SUBJECT: CONTROL ROOM DESIGN REVIEW/AUDIT REPORT, PALO VERDE  
UNIT 1

HUMAN FACTORS ENGINEERING  
CONTROL ROOM DESIGN REVIEW/AUDIT REPORT

PALO VERDE NUCLEAR GENERATING STATION  
ARIZONA PUBLIC SERVICE COMPANY

FIG. 1. Identification of control board surfaces.

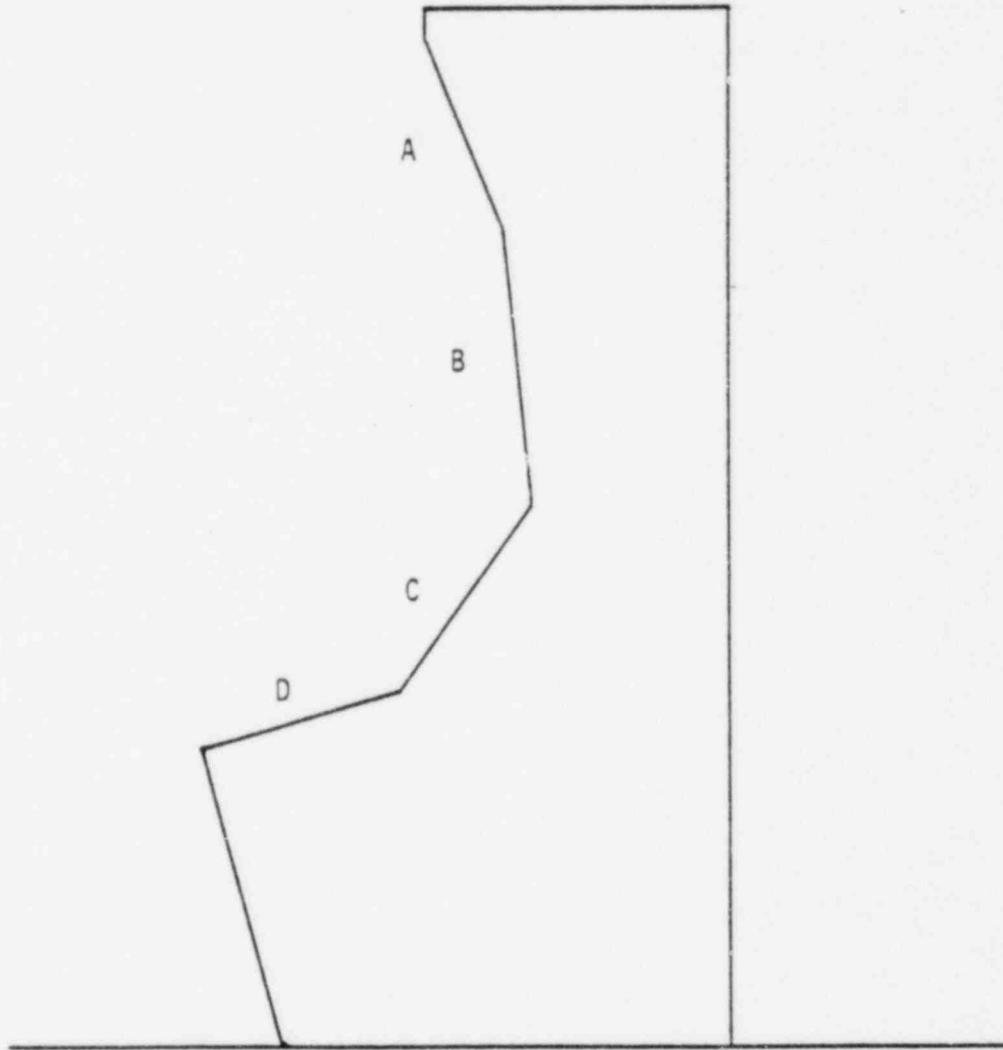
<u>PRIORITY RATING</u>	<u>FINDING</u>
3	1* The control room bookshelves are inadequate. (056C)
2	2* Glare is a problem for most displays on all of the panels. It is worst on the "C" surfaces, depending on viewing angle. (See Fig. 1 on page 3 for the meaning of "A", "B", "C, and "D" surfaces.) (049C) (064C) (100B) (101B) (103C)
1	3* Glare on CMC switch surfaces hinders "light-on" determination. This is more apparent on the "C" surfaces. A matte surface might not be as effective a solution as brighter lights. Example: (Panel B02) a.) ESF SWGRA/EQPT Room switch (098C)
31	4* The concrete control room floor is not carpeted, which will lead to earlier fatigue during long periods of standing by the operators. (068B)
